Access Compliance Report Public Rights-of-Way (Curb Ramps)

Main Street: FLINTRIDGE_AVE		Cross Street: FLINTRIDGE_AVE		Location:	NE
ADA ID: RPAT220208142648	Ramp Type: Type 4 - Parallel	Initial Pass/Fail: Fail	Overall Compliance: No	Severity Score:	15
Codes/Mitigation Info/Possible Solution			Field Measurements/Component Compliance

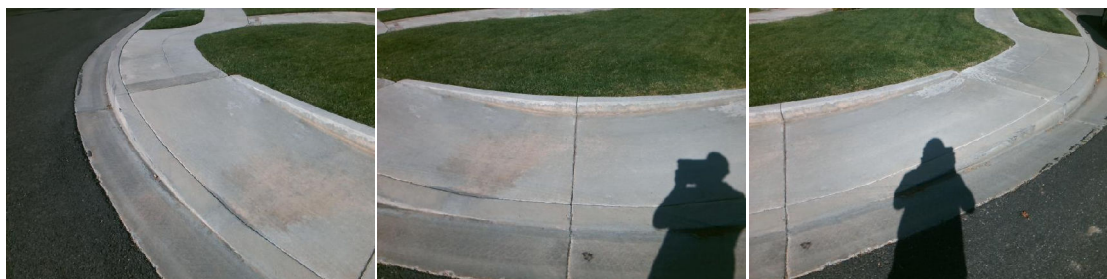
Compliance	Description	Data	Compliance	Description	Data
N/A	Ramp Length LT (in)	113	N/A	Ramp Length RT (in)	113
Yes	Ramp Width LT (in)	54	Yes	Ramp Width RT (in)	54
Yes	Ramp Run Slope LT (%)	4.9	No	Ramp Run Slope RT (%)	11.3
Yes	Ramp Cross Slope LT (%)	1.7	Yes	Ramp Cross Slope RT (%)	1.6
N/A	Landing Present	N/A	N/A	DWS Provided	N/A
N/A	Landing Length (in)	N/A	N/A	DWS Contrast	N/A
N/A	Landing Width (in)	N/A	N/A	DWS Length (in)	N/A
N/A	Landing Run Slope (%)	N/A	N/A	DWS Full Width	N/A
N/A	Landing Cross Slope (%)	N/A		DWS Offset Type	N/A
N/A	Landing Movement Obstructed?	N/A	N/A	DWS Offset Left (in)	N/A
	Landing Movement Type	N/A	N/A	DWS Offset Right (in)	N/A
N/A	Landing Shared	N/A			
N/A	Clear Space	Yes			
N/A	Clear Space To Crosswalk (in)	N/A			
N/A	Marked Crosswalk 1	No	N/A	Marked Crosswalk 2	No
	Crossing 1 Direction	W		Crossing 2 Direction	S
	Marked Crosswalk 1 Width (in)	N/A		Marked Crosswalk 2 Width (in)	N/A

Remove & Replace Curb Ramp With Two New Directional Ramps or Equivalent.
